**Kamman Hydrology & Engineering, Inc.**

Subject: Review of Final Environmental Impact Report  
SCH No. 2004031114  
The Church of the Woods Project, Rim Forest, California

FIGURE 1: Jurisdictional waters and wetlands from Church of the Woods DEIR (source: Thomas Leslie Corporation, 2005).

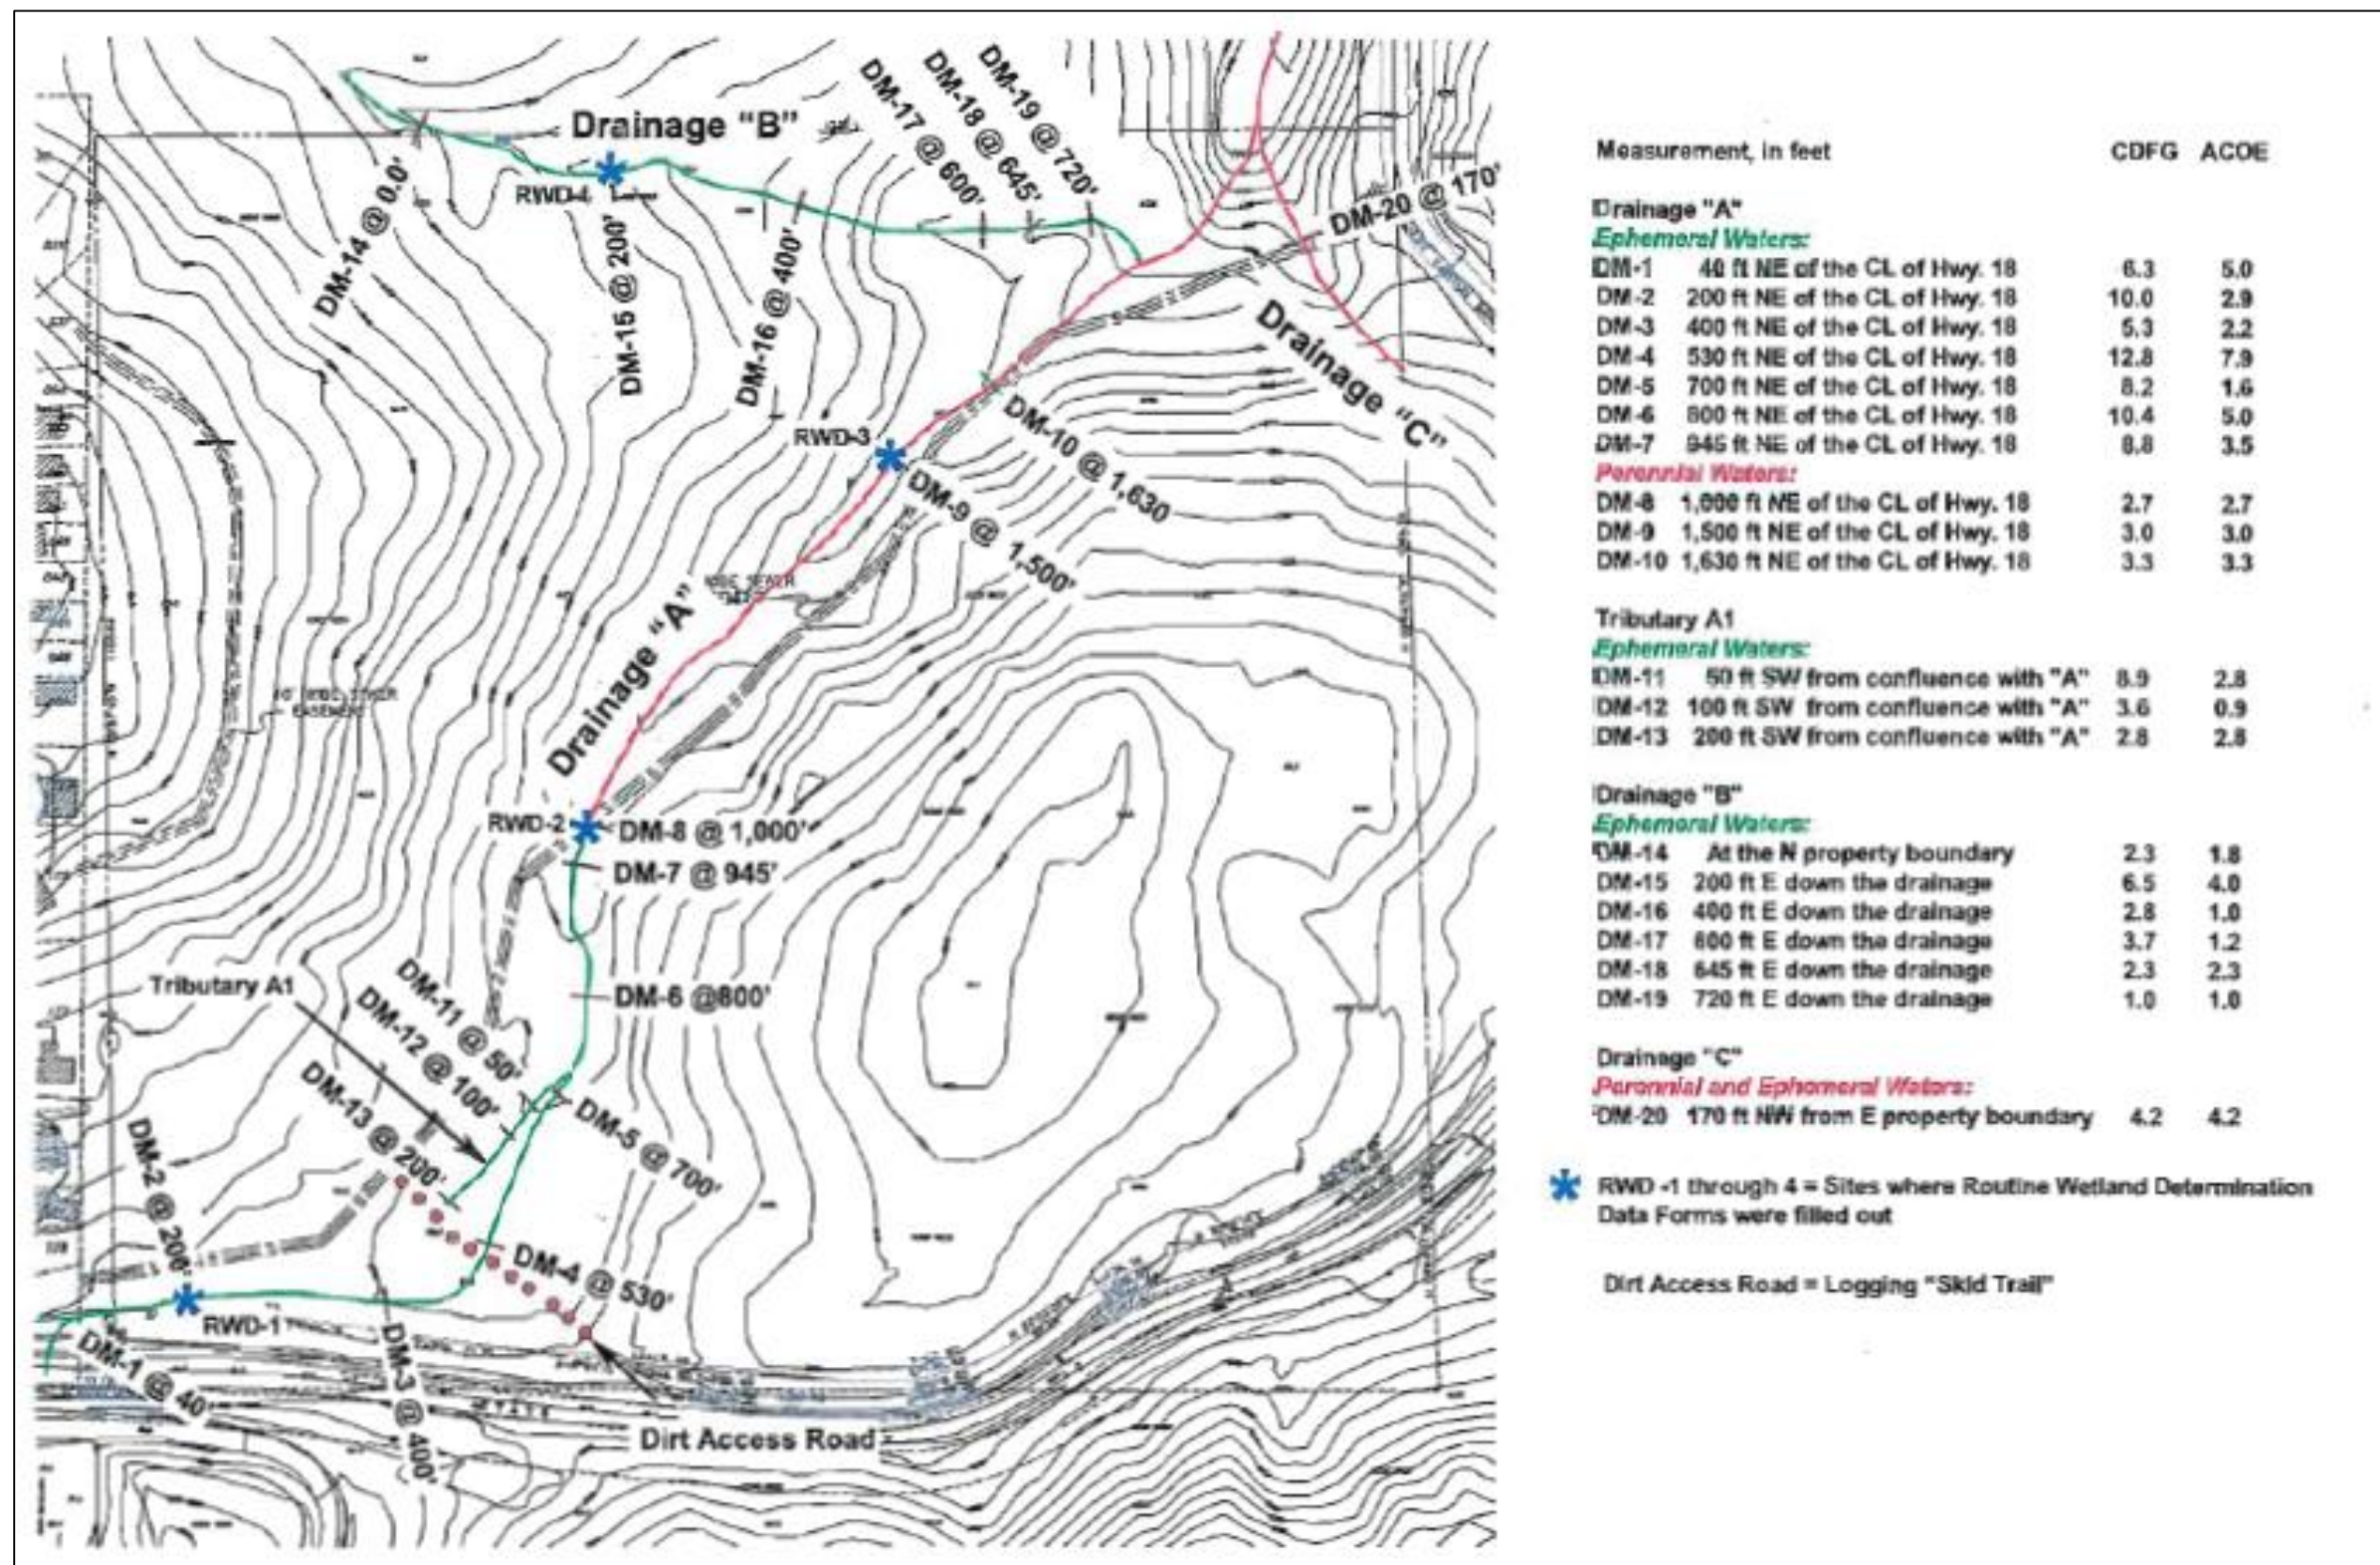
The COTW's delineation of jurisdictional waters and wetlands on the project property provided in Appendix C<sup>2</sup> of DEIR is consistent with the findings presented in the RSDP DEIR. Maps of jurisdictional wetlands/waters for the COTW and RSDP projects are provided in Figures 1 and 2, respectively. Both maps indicate that jurisdictional waters lie within the construction footprint of the proposed COTW project (Figure 3).

FIGURE 2: Jurisdictional waters and wetlands from Rimforest Storm Drain Project EIR (source: Aspen Environmental Group, 2015).

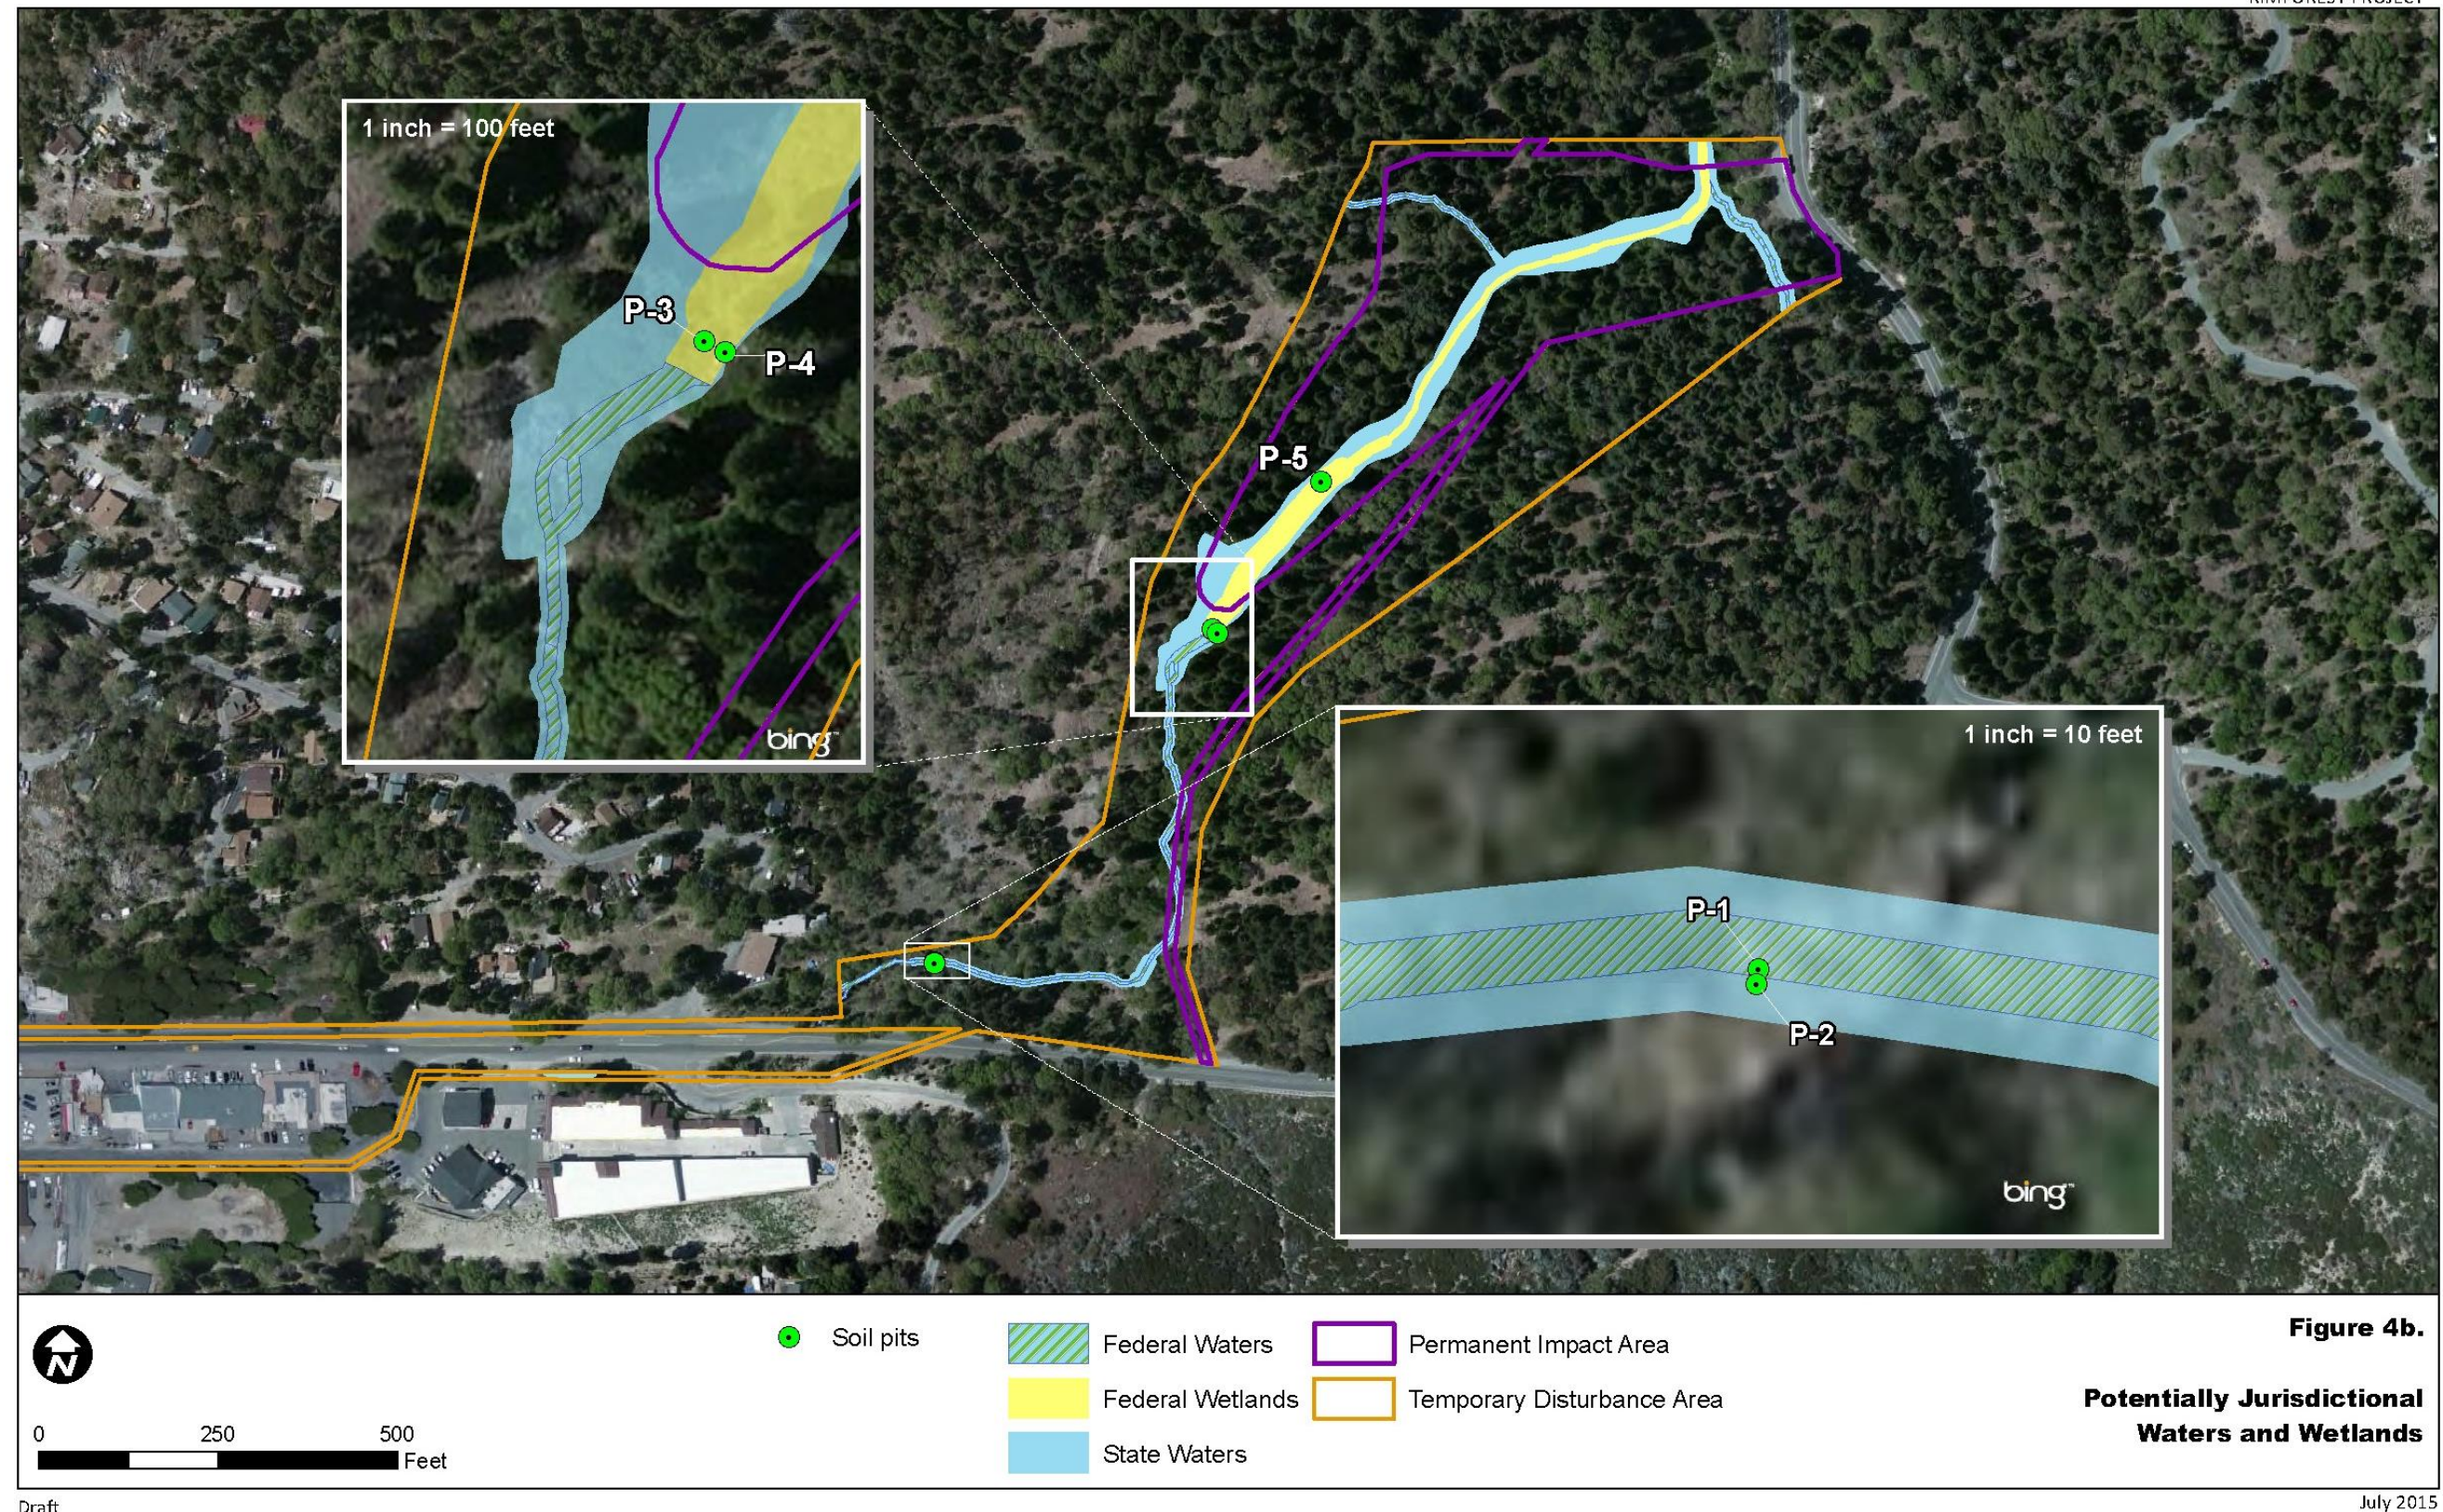
The RSDP identifies jurisdictional wetlands and waters that will be permanently impacted and temporarily disturbed during construction. These areas are delineated as "Permanent Impact Area" and "Temporary Disturbance Area" on Figure 2. The RSDP FEIR indicates that impacts to jurisdictional waters and wetlands within the Permanent Impact Area will be mitigated off-site by the County. Mitigation Measure BIO-1c of the RSDP FEIR states that jurisdictional waters that are disturbed within the Temporary Disturbance Area would be restored on-site. Specific language pertaining to on-site restoration of jurisdictional waters in Mitigation Measure BIO-1c is as following.
